MODEL 962

Model 962 test report

24 Sept 98

SCHEMATIC DIAGRAM OF MODEL 962 POWER SUPPLY/SPEAKER

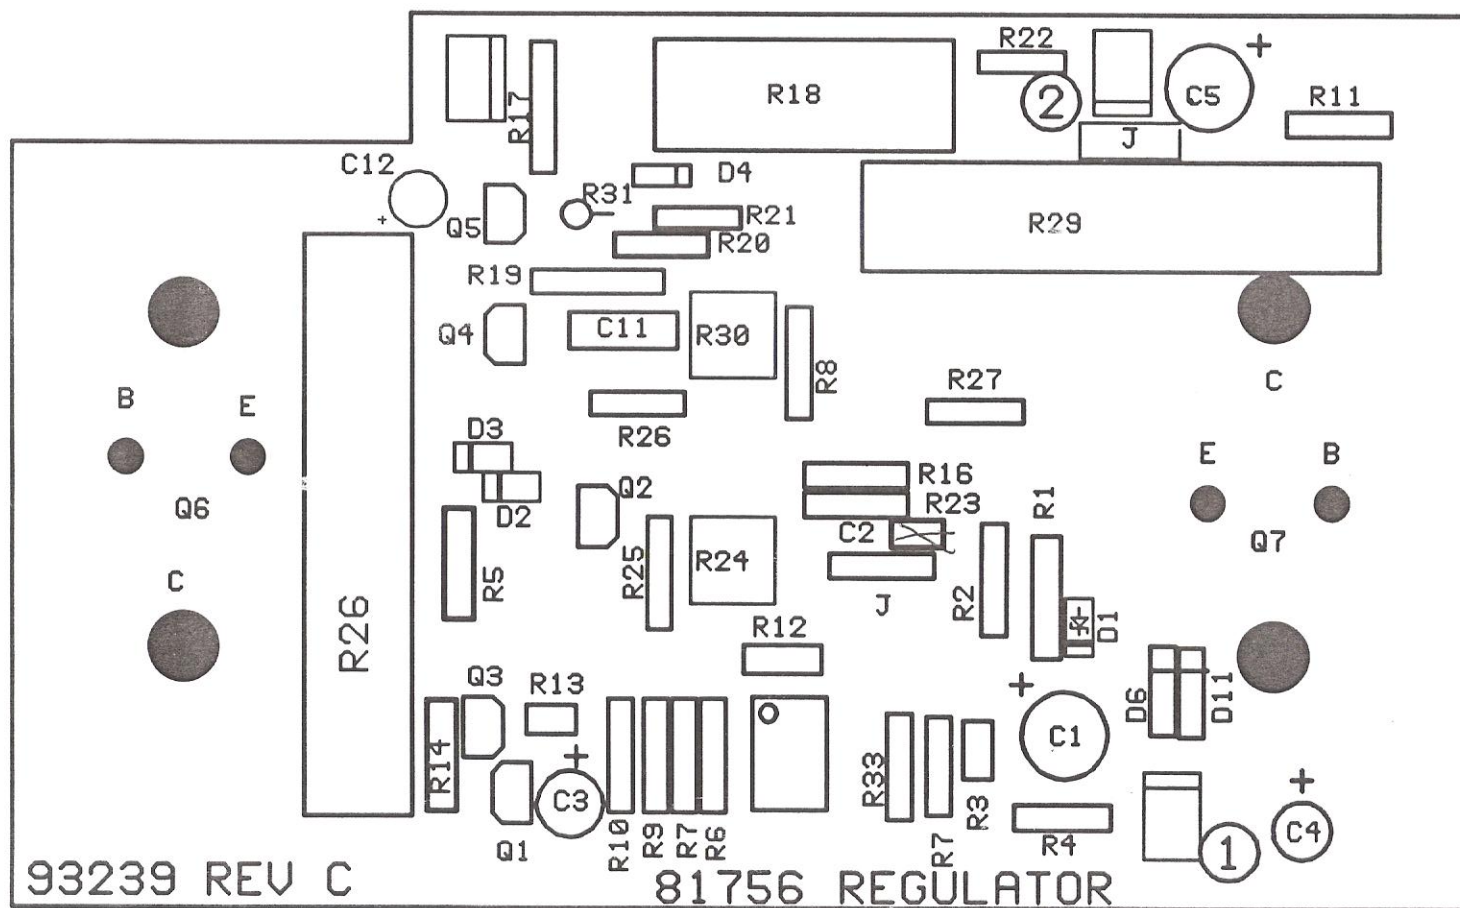
Voltage overshoot on turn-on causes 564 over voltage protection to "buzz"

Caused by c12 - r560 charge timepulls gnd and base of Q5 to B- till charged

Add 1000 uF to AUX 12 Vdc jacks on rear chassisThis caused over current trip on some units....

Change C12 from 33uF to 10 uF.....(R21-31 and C12 feedback gnd ripple to Q5 to reduce ripple on output).....this ripple was found on first run only with red zeners (change zeners also reduced ripple).

Change R10 from 1K to 4.7K To delay trip

MOVE C2 to IC #4+5
added GK resistor 1KΩ
